Philly Bike Action Response to PennDOT's proposed Market St Bicycle Detour

Last Updated: 03.25.2024

PennDOT [2.21.24](#) plan: [map](#)

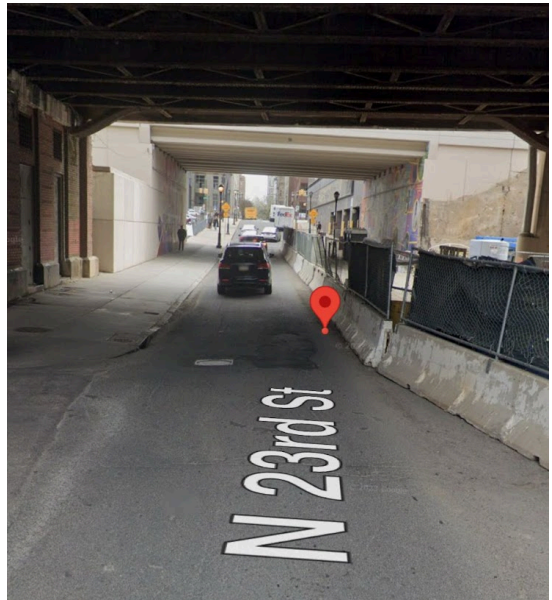
- **We have historical evidence that one lane of traffic on N 23rd St is workable.**

- Market St and 23rd was reduced to a single lane by construction for years
- Today, 23rd St under JFK is reduced to a single lane by construction. The construction under JFK is currently using the right-of-way to park a dumpster - this space could be reclaimed to accommodate a bike lane or, a left-side bike lane could detour onto the sidewalk under the bridge for the duration of the detour.

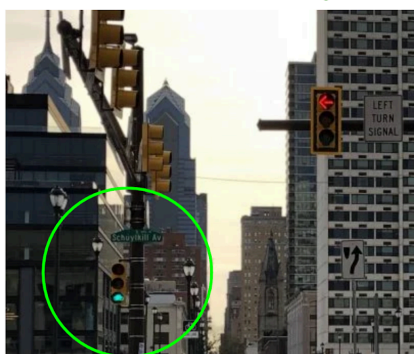
We are excited to hear that re-stripping the bike lane and installing a bike signal are planned for the bridge ahead of the detour. However, due to the high-speed nature of the road, the **bike lane needs to be protected by jersey barriers** during the detour.

- According to [City data](#), Walnut St is in the top 10 corridors for speed related crashes. Since parking protection is not being install until the conclusion of the detour, it's **imperative that concrete jersey barriers are installed immediately** to protect the bike lane from high-speed traffic, similar to Columbus Ave and Spring Garden St:
